ADDENDUM

Date Issued:	July 28, 2020
Project:	Intermountain Healthcare IMC- Cath Lab #9 Remodel 5121 South Cottonwood Street Murray, Utah 84107
Addendum Number:	1

Intermountain Healthcare
IMC- Cath Lab 9 Remodel Project

NJRA Project # 20205
 Construction Documents July 15, 2020
 Addendum #1 July 28, 2020

1 Demolition Floor Plan
SCALE: 1/2" = 1'-0"

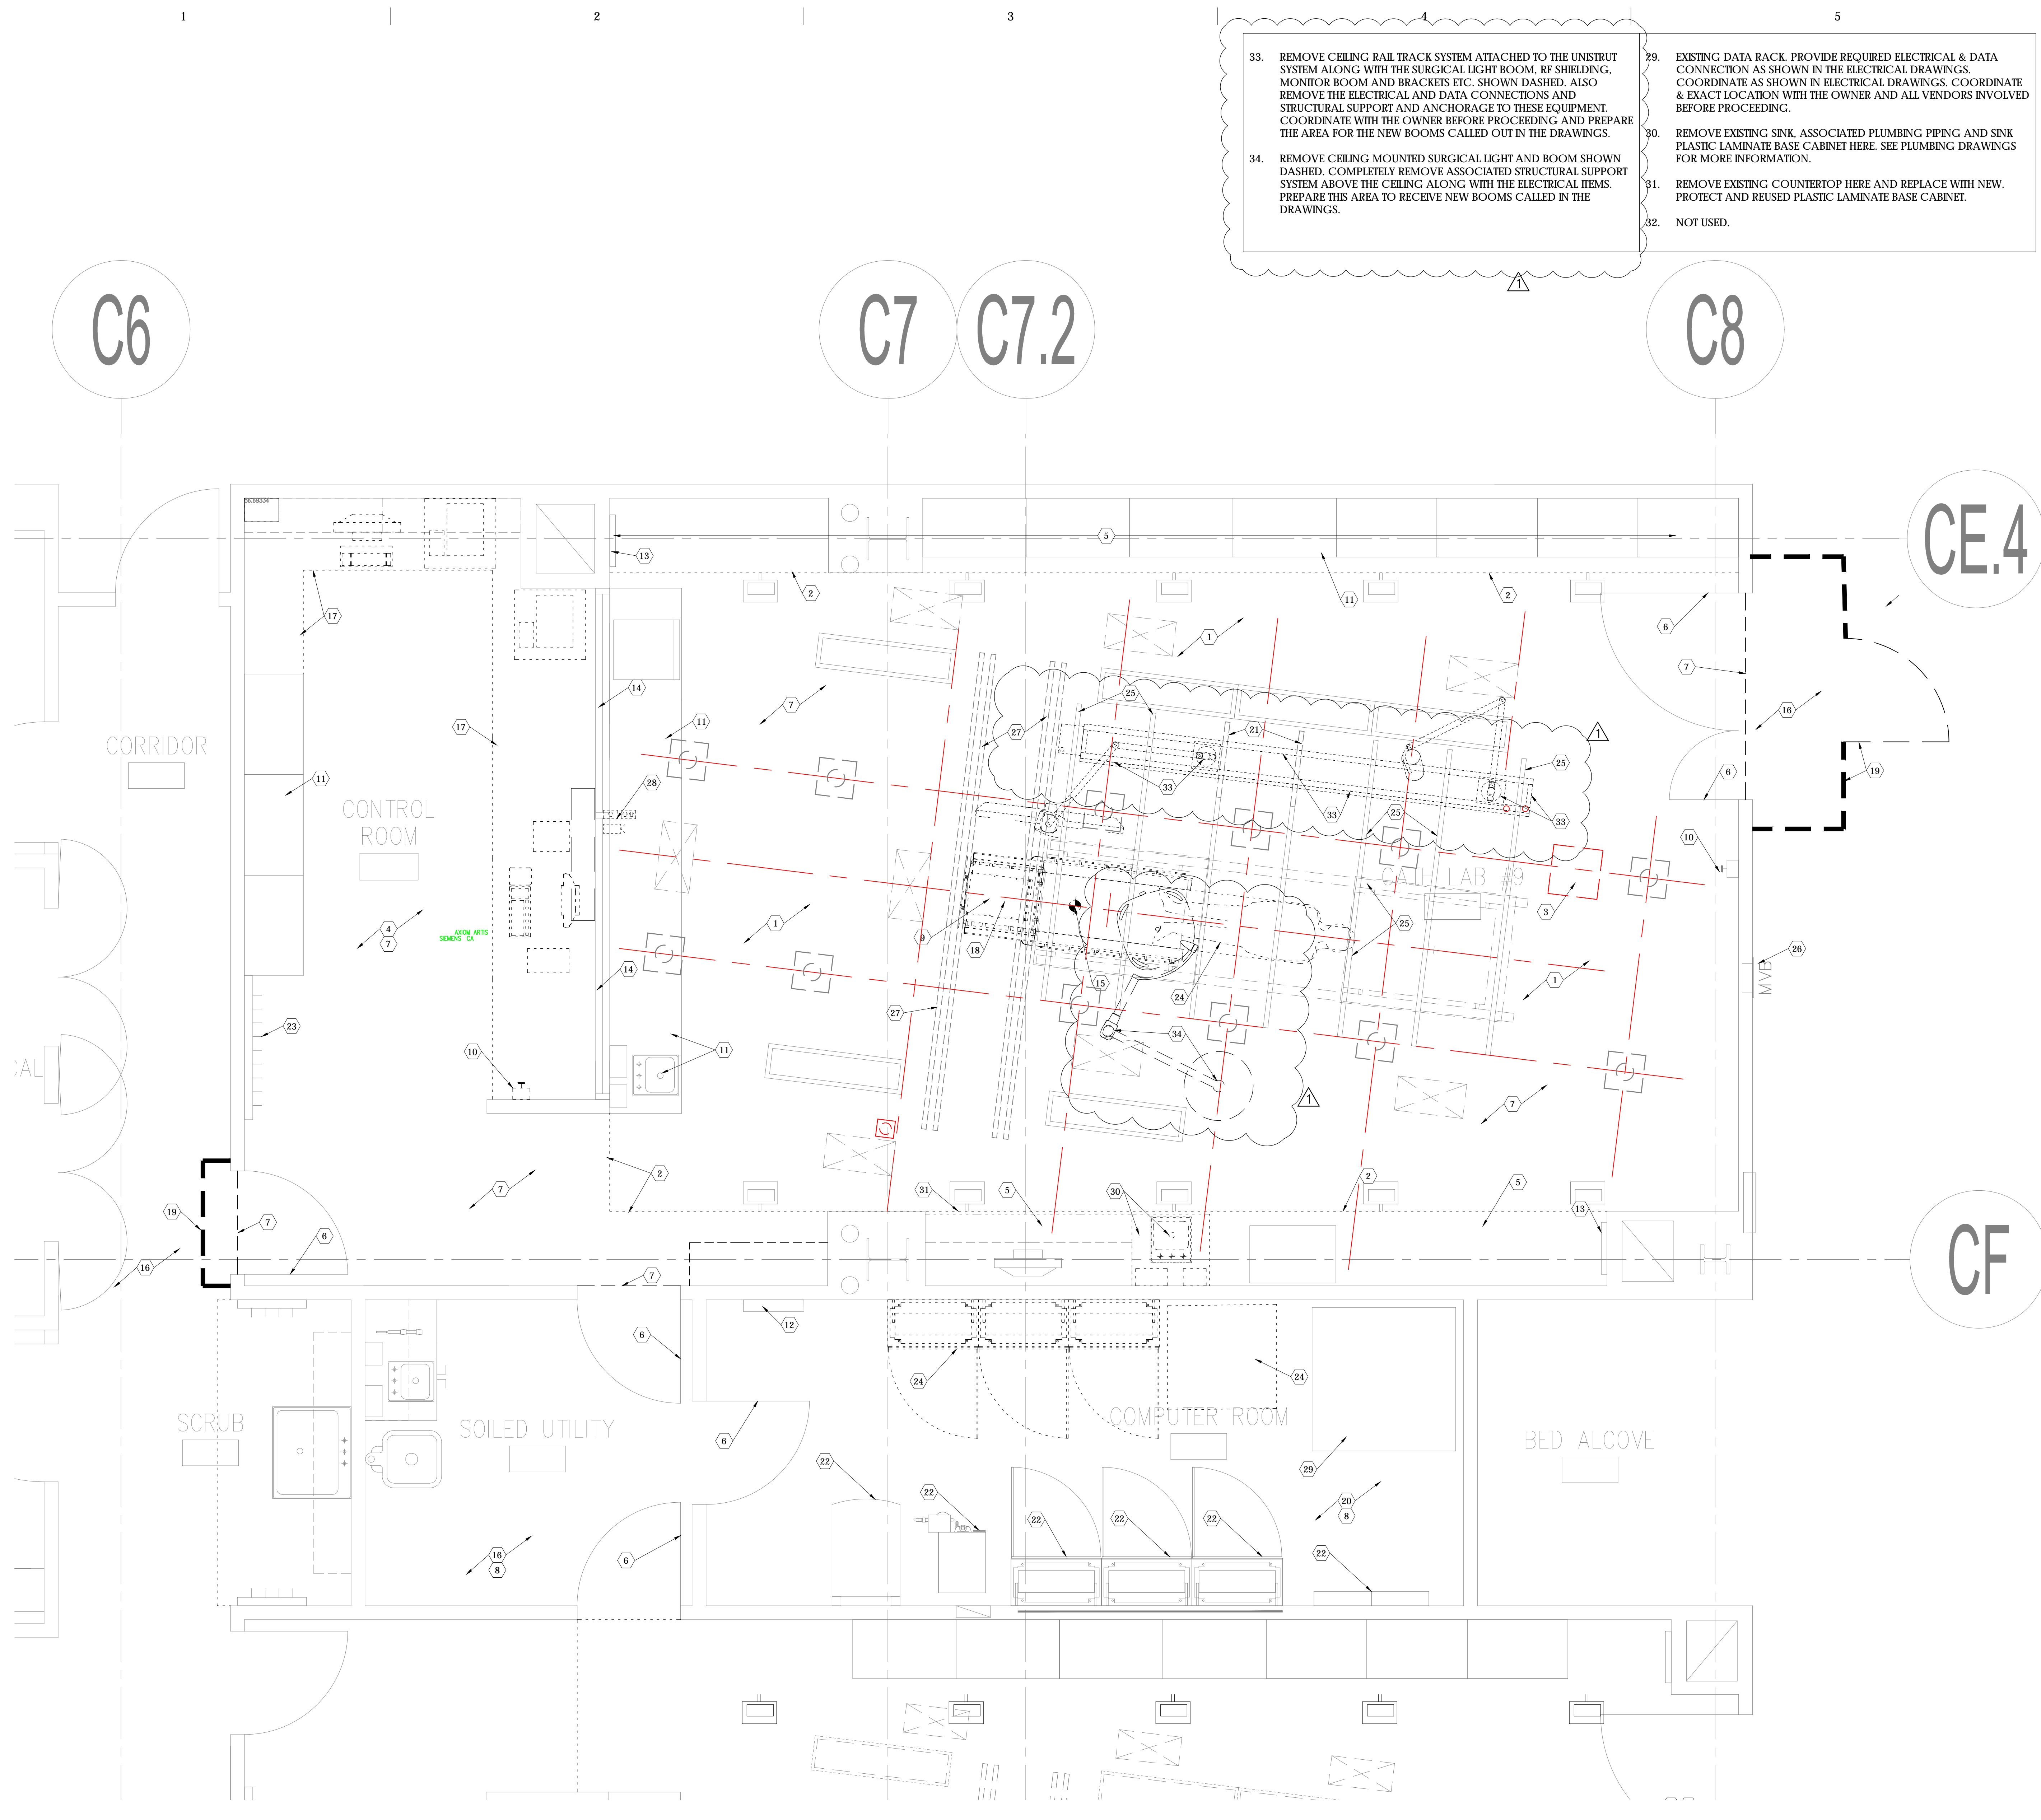
Sheet Number	Drawings
Architectural	
A101	Notes have been added to the demolition floor and ceiling plan. See attached revised sheet with revisions shown clouded.
A111	New cabinet and millwork called out in the drawings have been revised. See attached sheet with revisions shown clouded.
A502	Detail and elevation for the cabinet has been revised. See attached sheet with revisions shown clouded.
Equipment Drawings	
EQ109	See attached revised Skytron boom layout drawings. New boom locations have been coordinated and updated with Architectural drawings.
